COMMENT REPORT

CASE NUMBER: C814-2021-0099

PROJECT NAME: Brodie Oaks Redevelopment

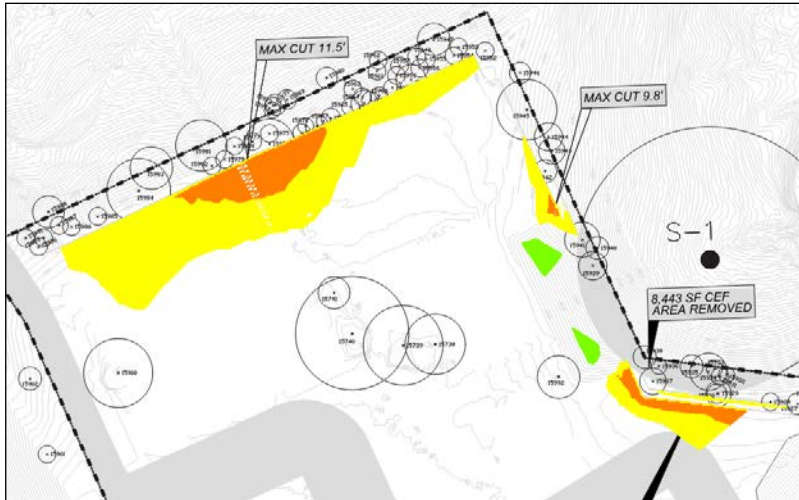
- EV3. *Exhibit G: Grading Plan.* Clarify whether the cut shown in the image below is “for construction of a water quality control or detention facility and appurtenances for conveyance such as swales, drainage ditches, and diversion berms” [LDC 25-8-341(A)(4)].

Update 1: Comment pending. Please explain the reasons for the cut and fill shown in these locations. I do not foresee any issues. However, I would like to have this information for my records. Approval of the related code modifications to allow this grading is pending. (25-8-341 & 342)

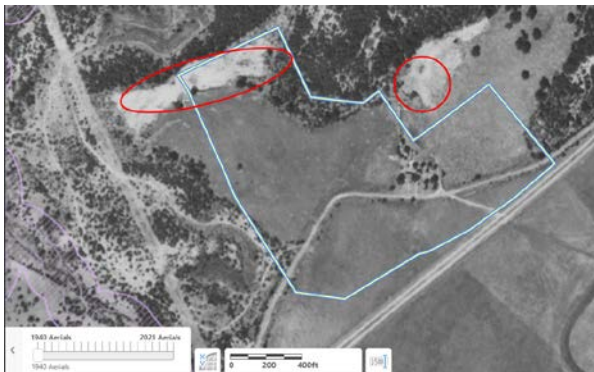
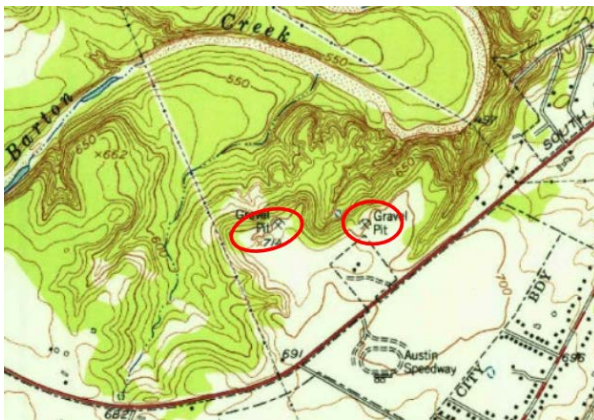
- EV6. 25-8-341/342. If the development “is proposing to restore the site back to original pre-development grades,” modifications to 25-8-341 & 342 may not be necessary. Grading is measured from the original elevation, so returning the site to original grades will require less rather than more grading. Please do more research to get a better idea of the pre-development elevations. The image below is from 1940 and is available on Property Profile. The topo was provided by the previous reviewer.

Also, it looks to me as if the two gravel pit areas shown on the topographic map (1955?) are outside of the areas where grading is proposed with this project.

Update 1: Comment cleared.

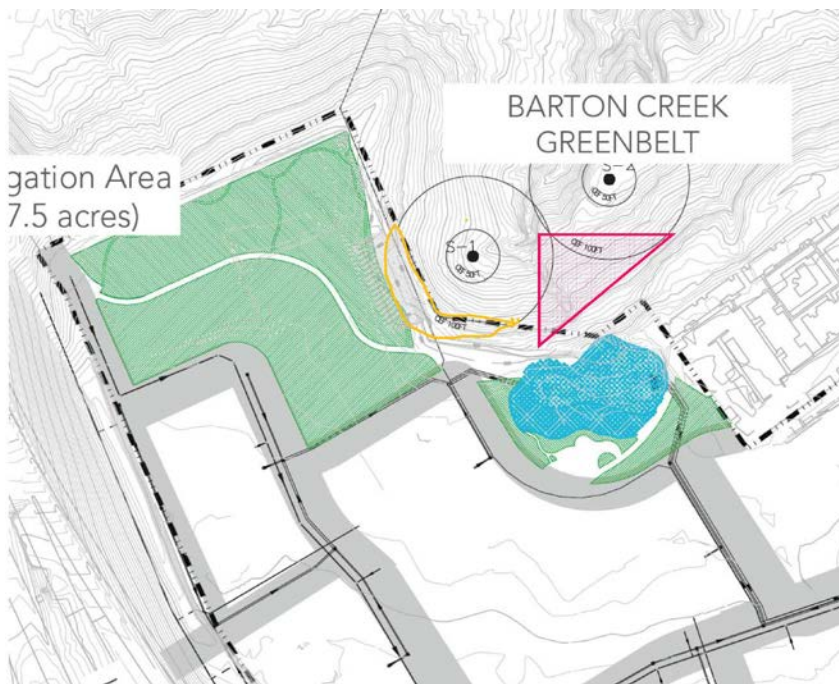
- HG 5. Please calculate area of reduction for setback S-1 (orange) and incorporate into the buffers on the upslope side between S1 and S2 (pink). See picture below for additional clarification.

Update 1: Comment cleared. Area removed is less than proposed modification of setback. Proposed setback will still protect character of hydrogeologic CEFs.

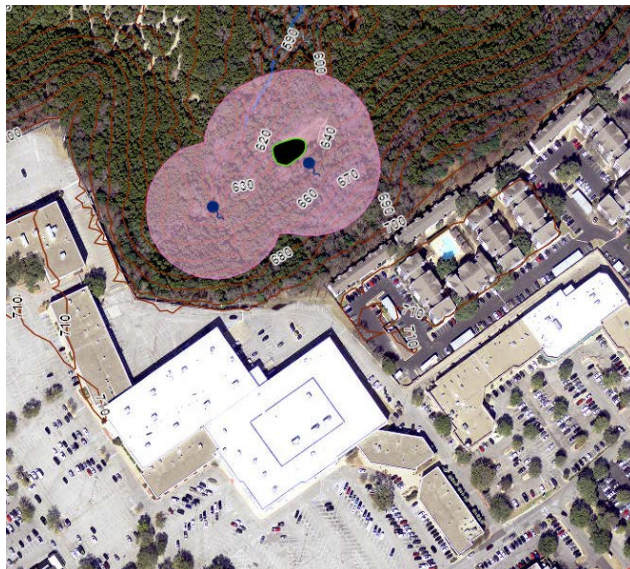
Update 1: A previously identified wetland CEF (BRG ID 207473) was identified and field verified by WPD staff on-site associated with the spring CEF (S-2 as labeled on the plan sheets). Please see the screenshot below of the approximate location and boundaries of the wetland CEF, which are available on Property Profile Tool. In addition, the Shapefiles for the wetland CEFs are available on Property Profile to be downloaded. To clear this comment:

- Please clearly show the boundary of the wetland CEF and clearly label the feature: “WETLAND CEF” on all plan sheets where it exists.
- Please clearly show and label “WETLAND CEF SETBACK” the standard 150 ft CEF setback on all plan sheets where the CEF and CEF setback exist.
